TECHNICAL AND SERVICE BULLETIN

NO. 721
DATE: MAY 1990

TO: All Kompac Dealers
SUBJECT: KolorMate Retrofit Update

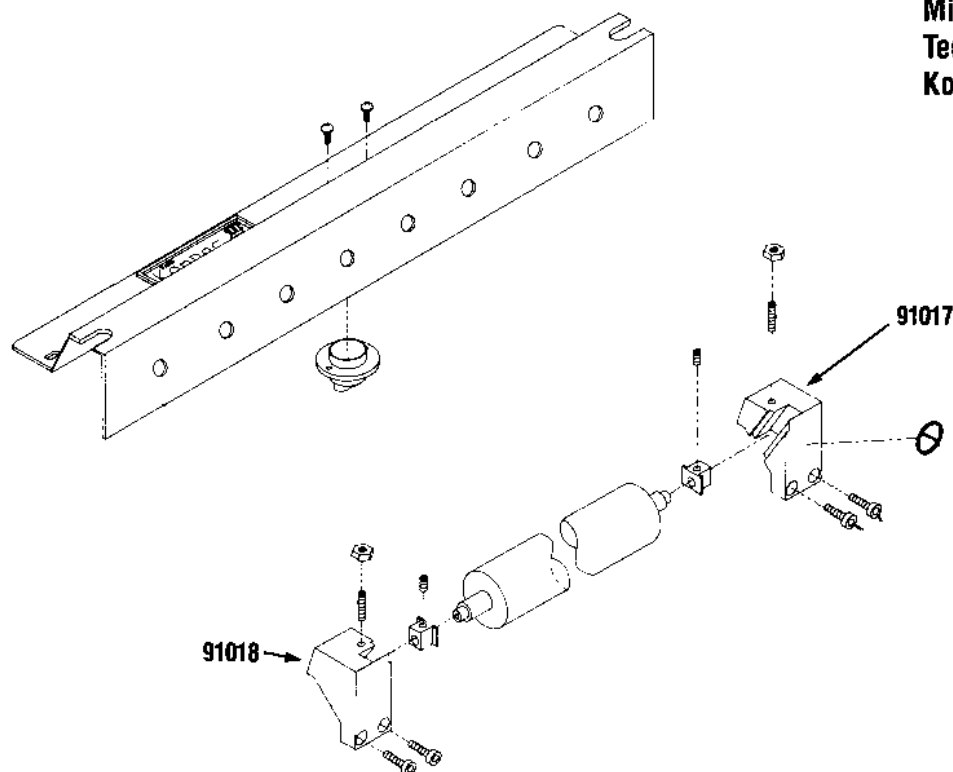
New end blocks are available which will enable operators to adjust the pressure applied to the KolorMate oscillator roller. This will eliminate flashing and other related problems. The end blocks will be included with all new KolorMate units. If you require a set of these end blocks for units currently in the field, please order them, at no charge, by the part numbers listed below.

Note: Kompac safety cover must be modified to accept new blocks.

Part No.	Description
91017	R.H. Oscillator End Block
91018	L.H. Oscillator End Block
